Informal document No. GRSG-96-27
(96th GRSG, 4-8 May 2009
agenda item 5)

Proposal for draft amendment to Regulation No 118
(Burning behaviour of materials)

Figure 4
Apparatus for testing the capability to repel fuel or lubricant
(Dimensions in millimeters)"

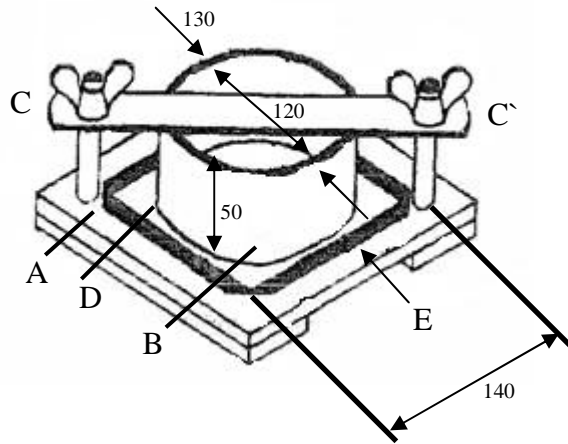
3. Apparatus (see figure 4)

A a base plate with an absorbant surface (e.g. paper);

B a metal cylinder (inner diameter of 120 mm, outer diameter 130 mm, height of 50 mm), filled with the test medium;

C - C` two screws with wing nuts;

D the test sample;

E a seal plate, with an hardness of 70 Shore D.
